ADDENDUM NO. 2

Reference: Student Activity Center Addition to the Stromberg Athletic Complex
Weber State University – Ogden, Utah
DFCM Project No. 12031810

Addendum 002

project:	WSU Stromberg Student Activity Center	**project no:**	12475
date:	2012-10-15	**no. pages:**	75
owner:	DFCM		
contractor:			
bid date:	2012-11-01	**bid time:**	12:00 pm

A1 DEMOLITION SITE PLAN

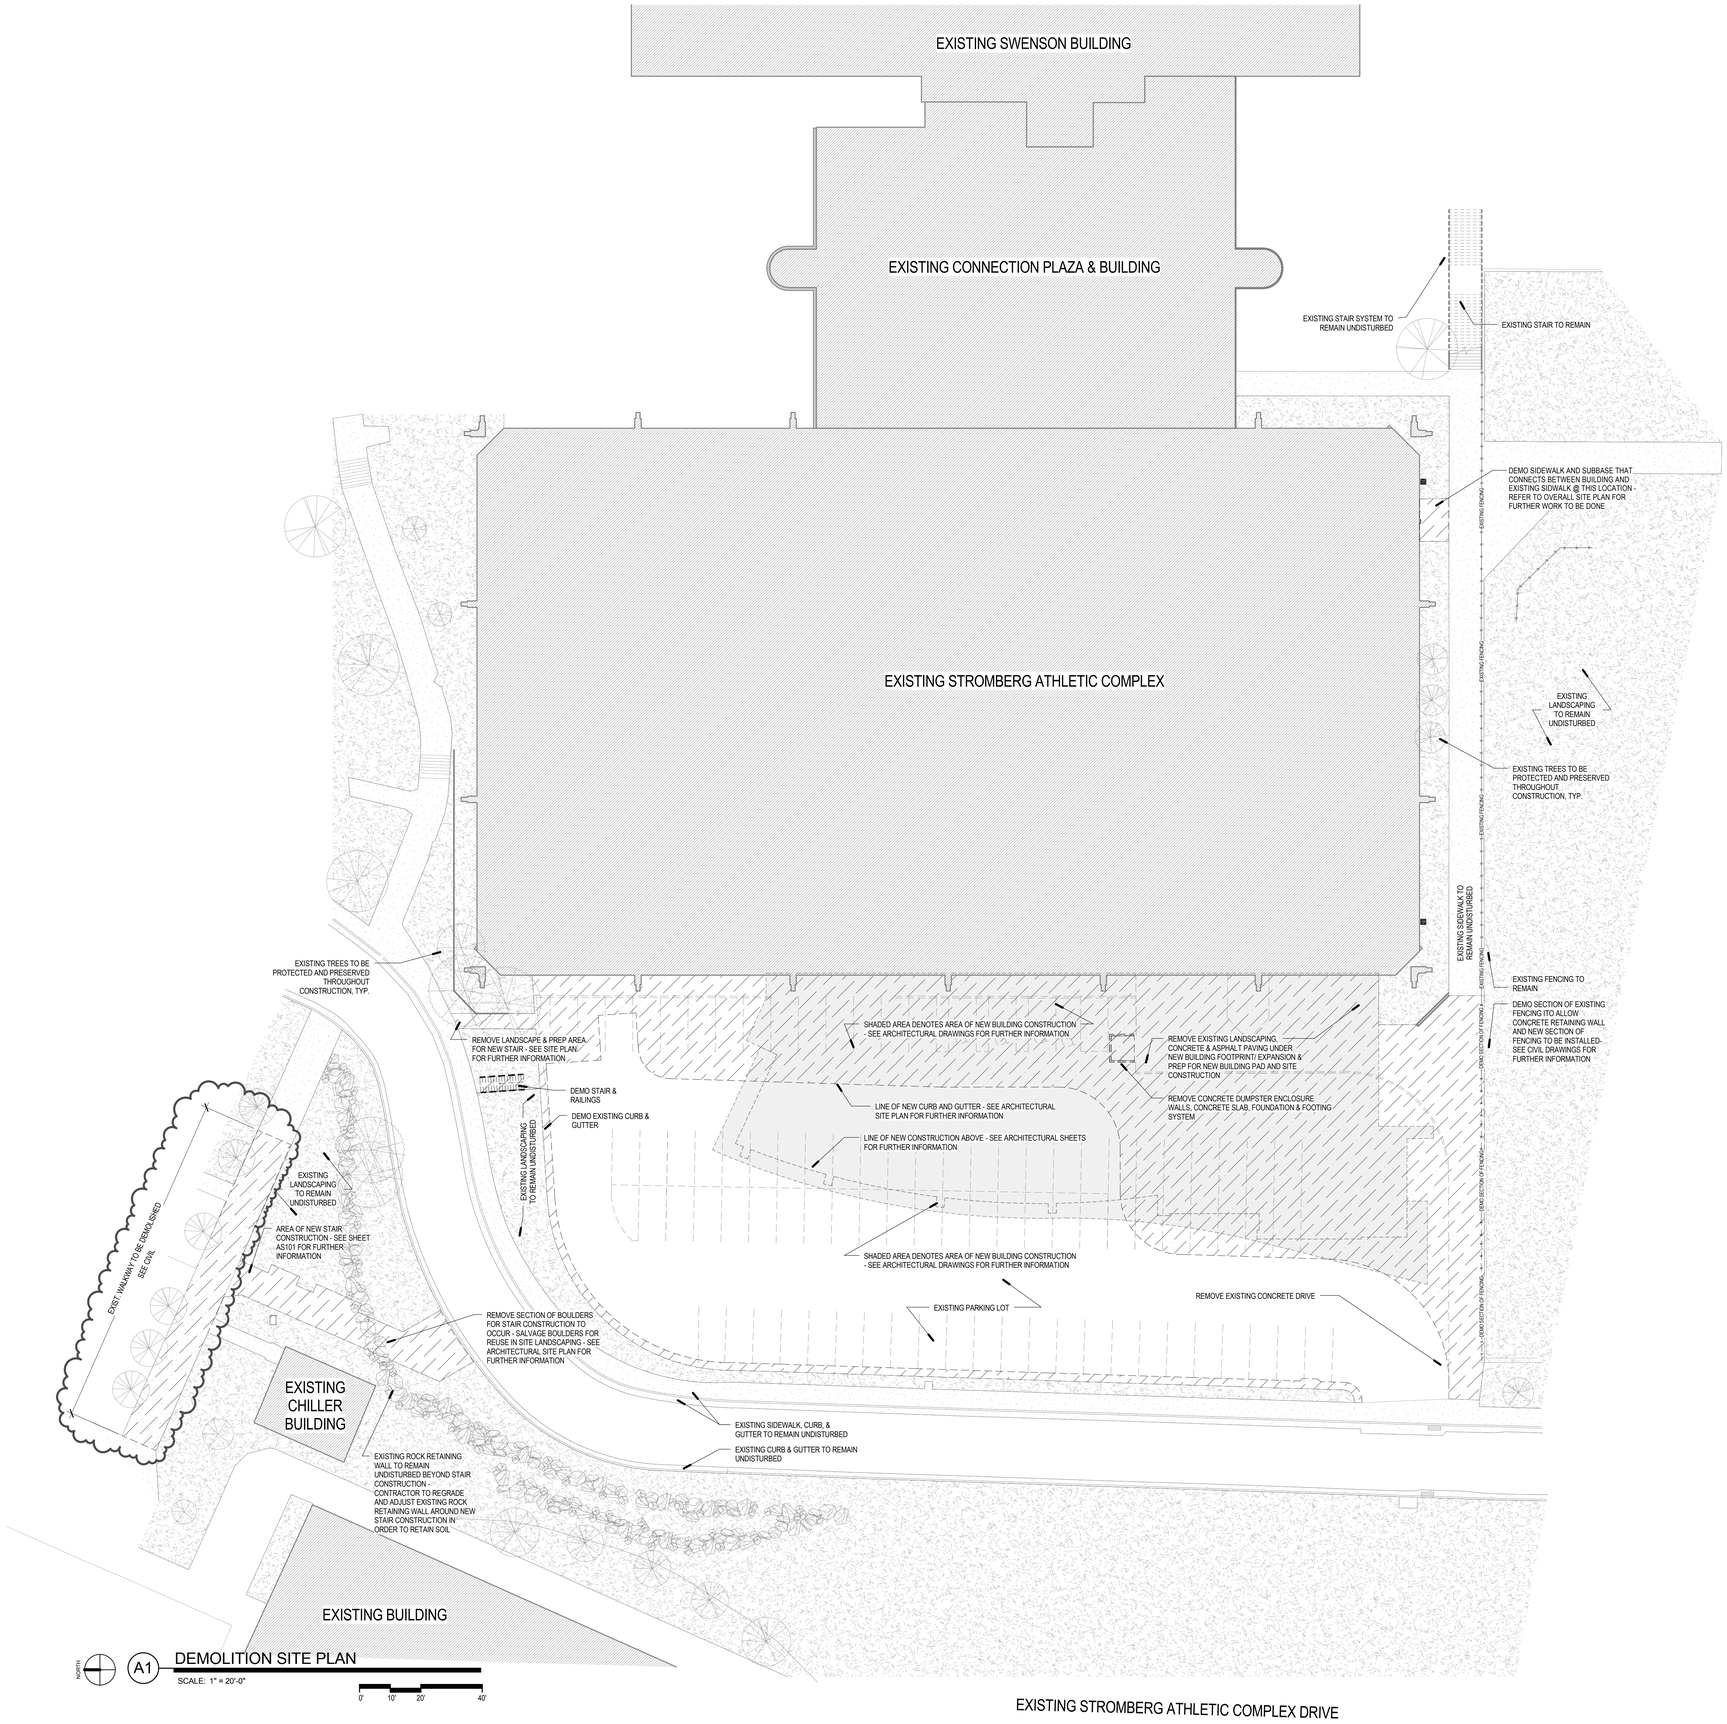
Item	Drawing No	Description
2.1	ADS101	Portion of existing concrete sidewalk to be demolished at the base of the new site stair as shown on the Civil Demo Plans. See revised attached sheet.
2.2	A113.1	Revised dimension at Grid F/1 and Grid F/2. See revised attached sheet.
2.3	A113.4	Add ceiling Type A to lobby. See revised attached sheet for scope.
2.4	A122.2	Storage 209A - demolish existing framed walls. Add a guard rail between the existing upper level and the Storage 209A addition. See revised attached sheet for location.
2.5	A133.4	Added ceiling at stair tower and lobby. See revised attached sheet.
2.6	A510	Note added on Detail B5. See revised attached sheet.
2.7	A511	Detail added: C5/A511. See revised attached sheet.
2.8	A521	Revised all details. See revised attached sheet.

C5 SOFFIT @ COMPOSITE METAL BROW
SCALE: 1 1/2" = 1'-0"
ADD #2

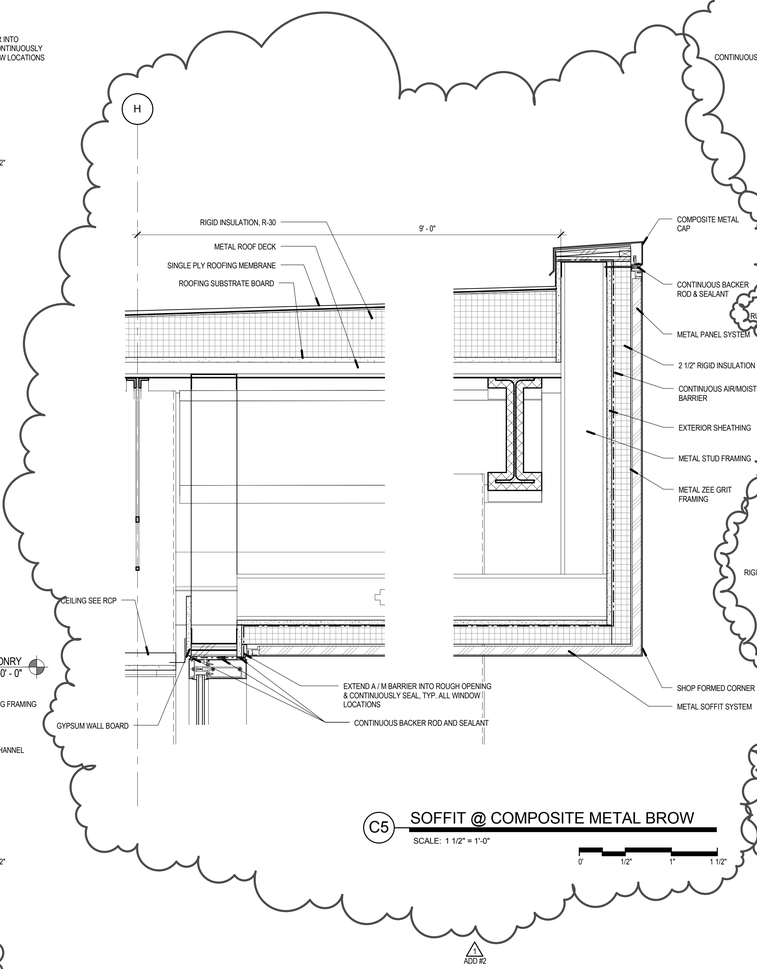
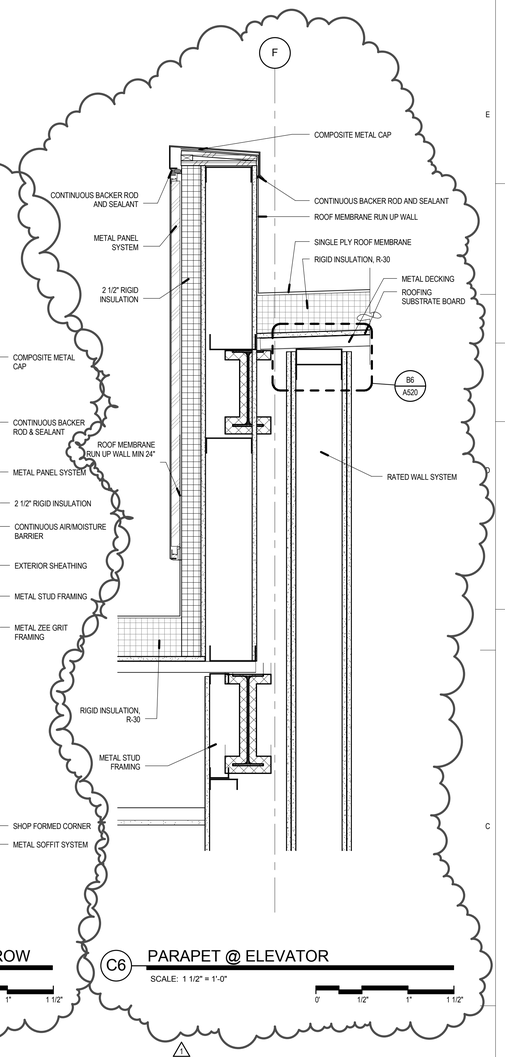
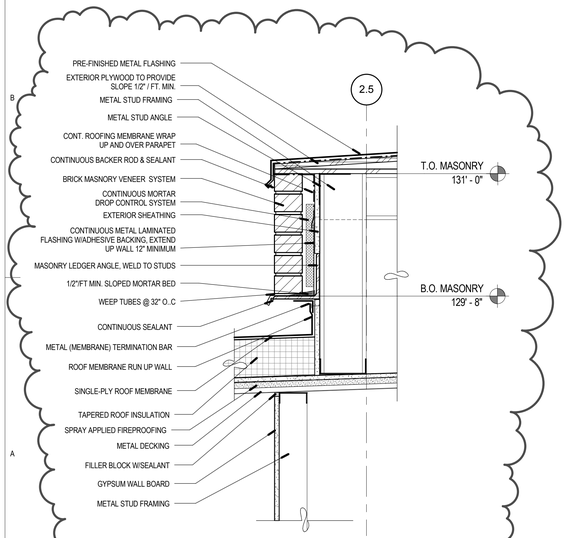
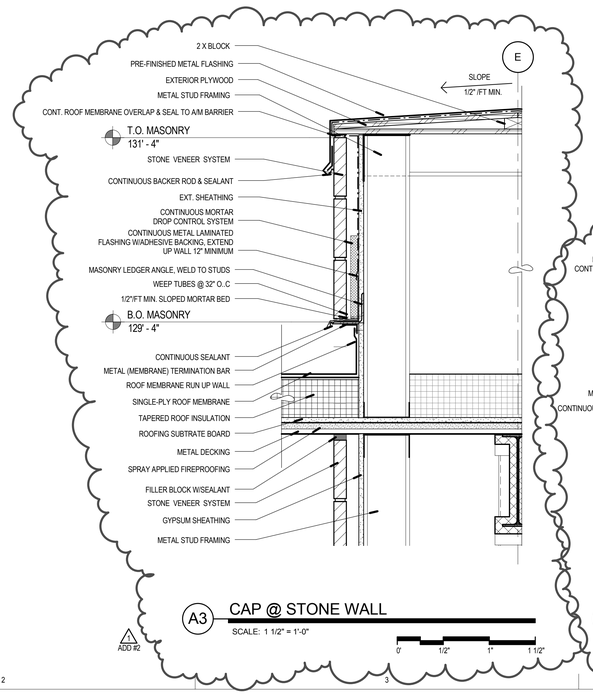
2.9	A531	Details added or revised: C5, C6, A1, A3, A4 and A5/A531. See revised attached sheet.
2.10	A570	Revised Millwork Details: D2, D3, D5, E6 and B5/A570. See revised attached sheet.
2.11	A571	Revised Countertop Detail C2/A571. See revised attached sheet.
2.12	A572	Revised Bench Detail D4/A572. See revised attached sheet.
2.13	A580	Revised detail call out at C4/A580. Detail call out to read: E5/A580 in lieu of E5/A540.
2.14	A600	Dimension change to A5/A600. See revised attached sheet.
2.15	A601	Revise the Hollow Metal Door Frame Type 8 to be a 4" head where installed in masonry walls.
2.16	A610	Dimension change to A6/A600. See revised attached sheet.

S112

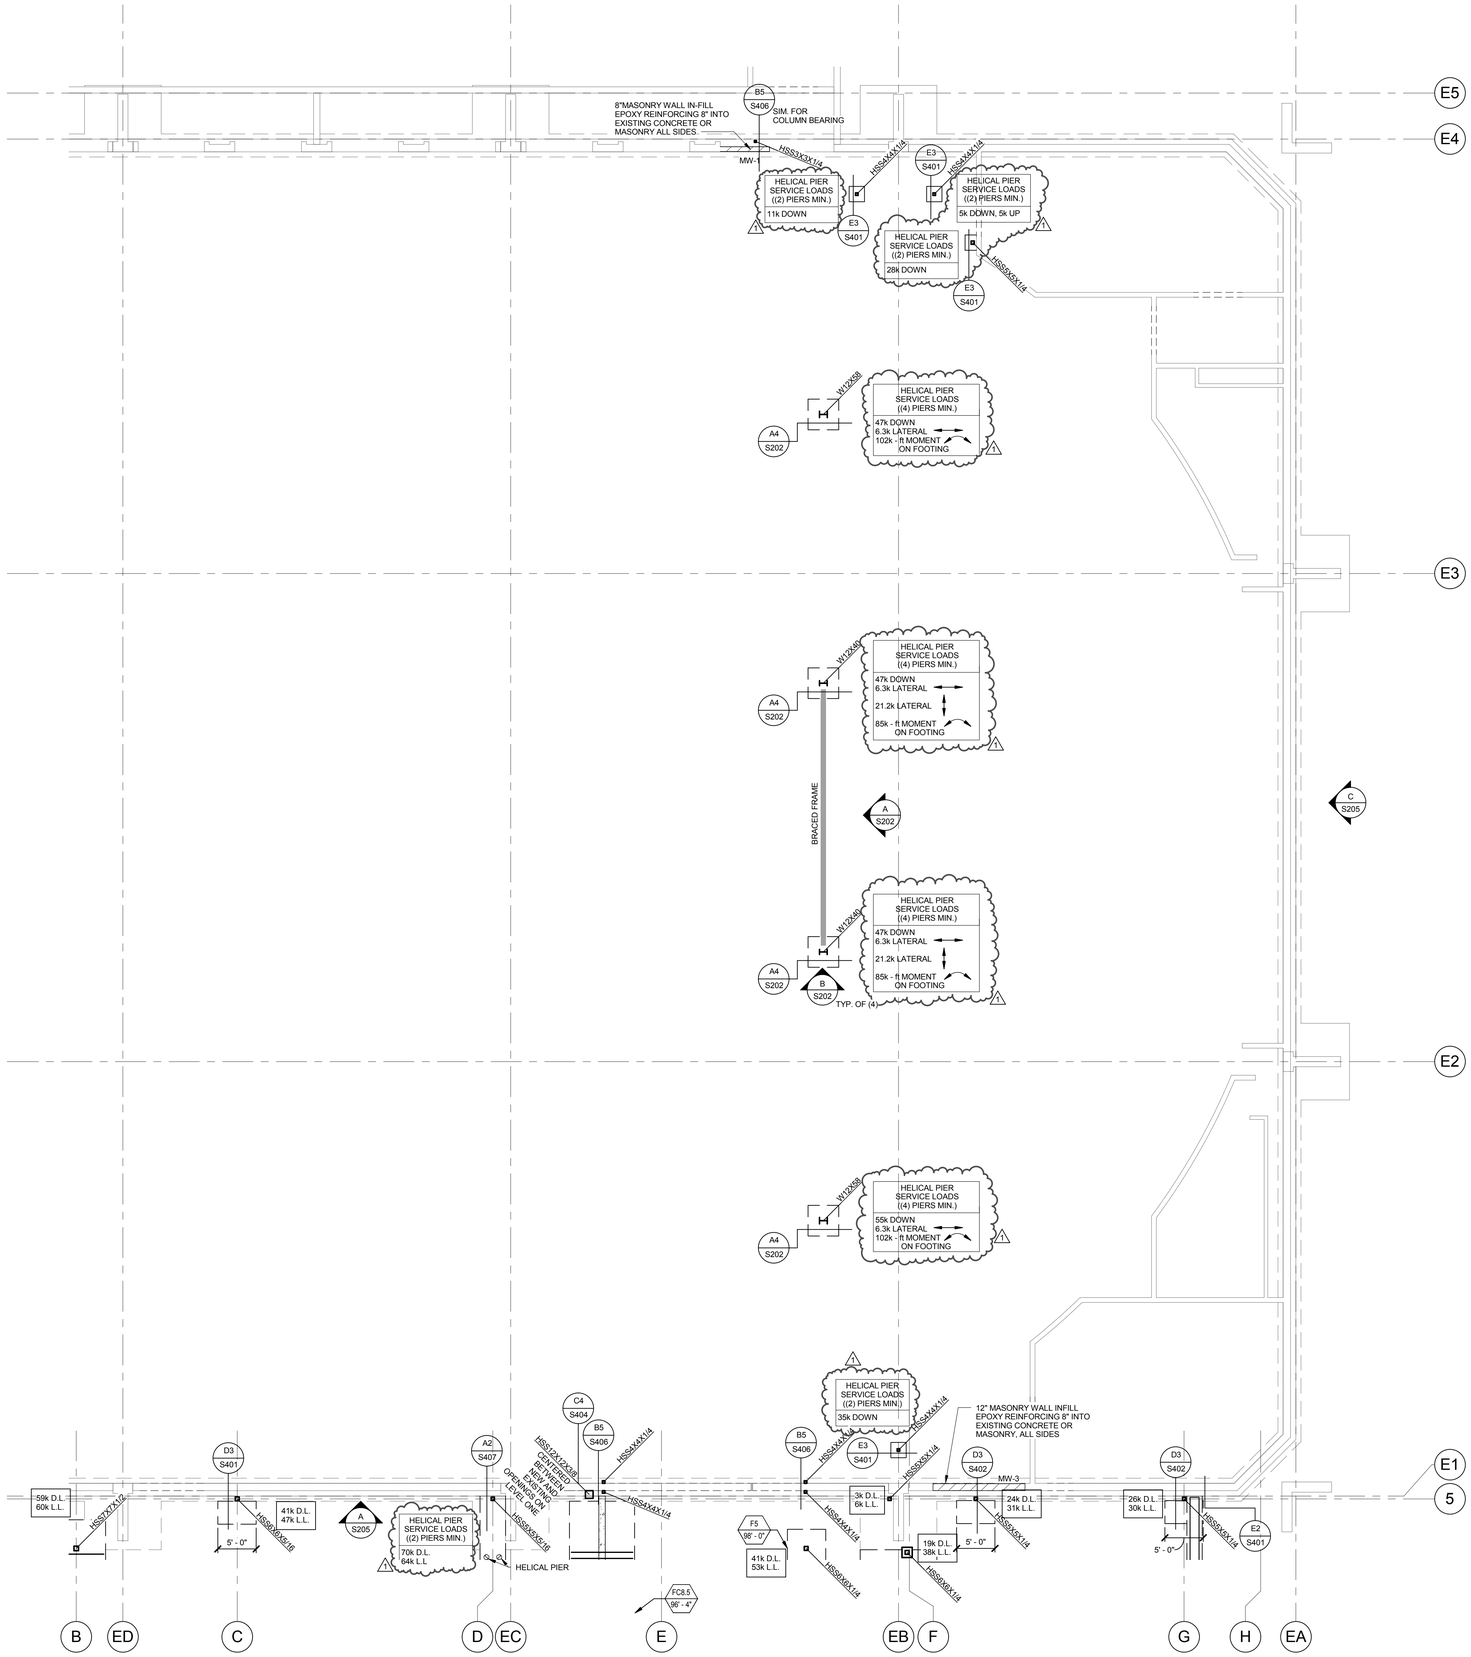
Sheet S112
-The footing and foundation plan for the bridge has been revised to clarify helical pier design loads and footing requirements.

S113

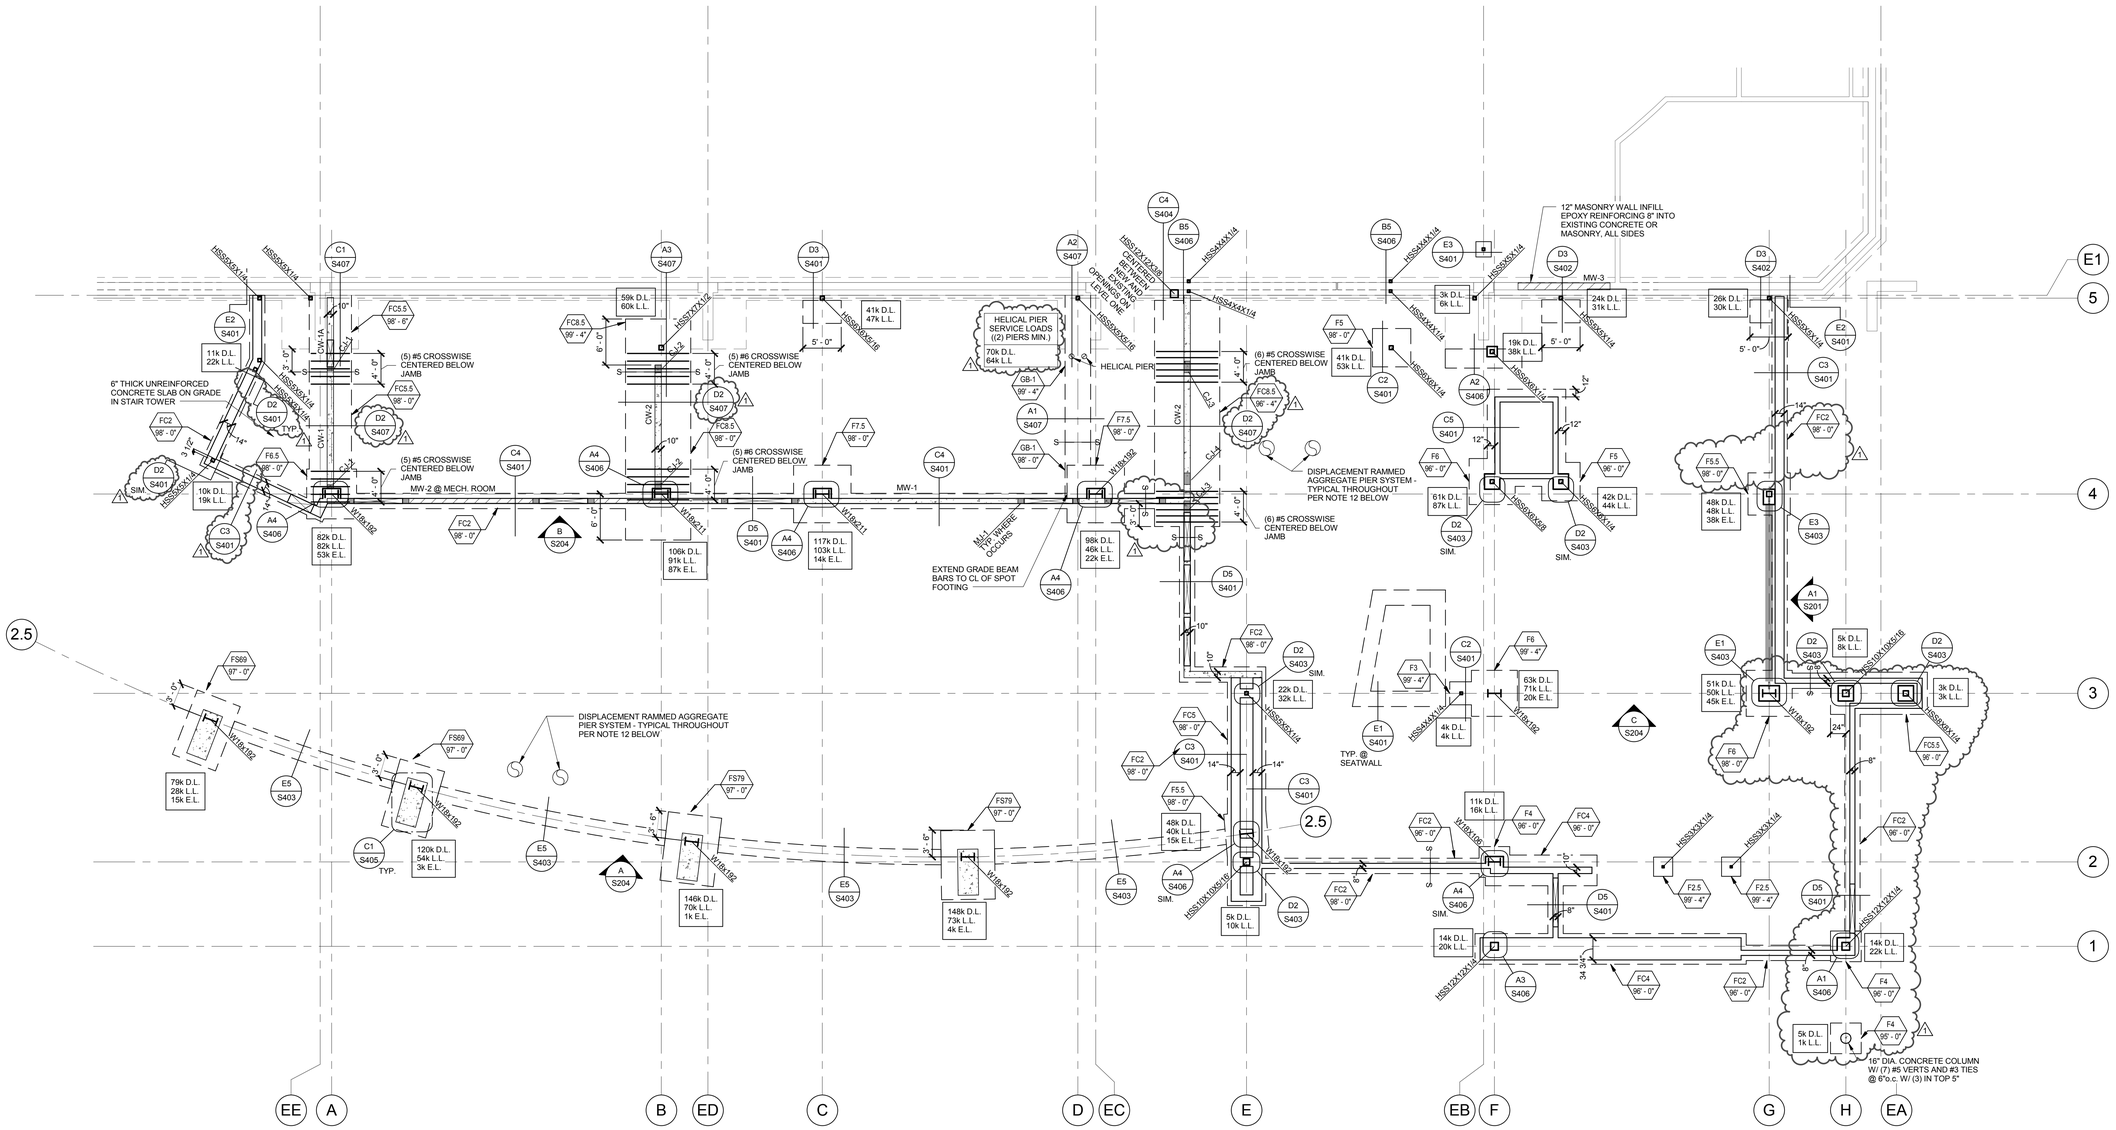
Sheet S113
-Footing elevations have been revised based on final grading plans and mechanical piping coordination.
-Additional details have been provided at the north stair.
-Footing and foundation notes have been revised.
